Norban Comtex Ltd (10050)

20.APRIL.2014

ACCORD
on Fire and Building Safety in Bangladesh

High Column Stresses

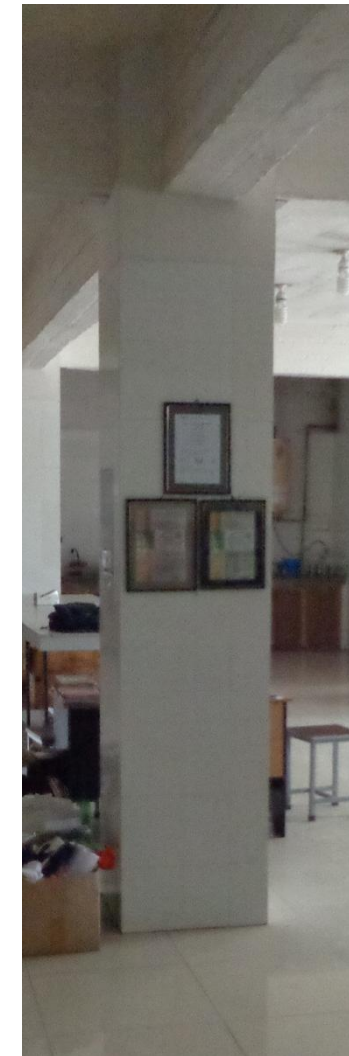
Within the Services Building and the Garment Pump house column load run-downs indicate higher than desirable levels of stress.

High Column Stresses.

Priority 1 (Immediate – Now)

- Remove storage loads from all floors above basement level.

Priority 2 (within 6 weeks)

- Factory Engineer to review design loads and column stresses in both the Services Building and the Garment Pump house Building. Additionally, the Factory Engineer is to conduct a thorough review of the as-built Garment Pump house structure.

Priority 3 (within 6 months)

- Formulate, implement and actively monitor a slab loading plan for all floor plates within the factory.
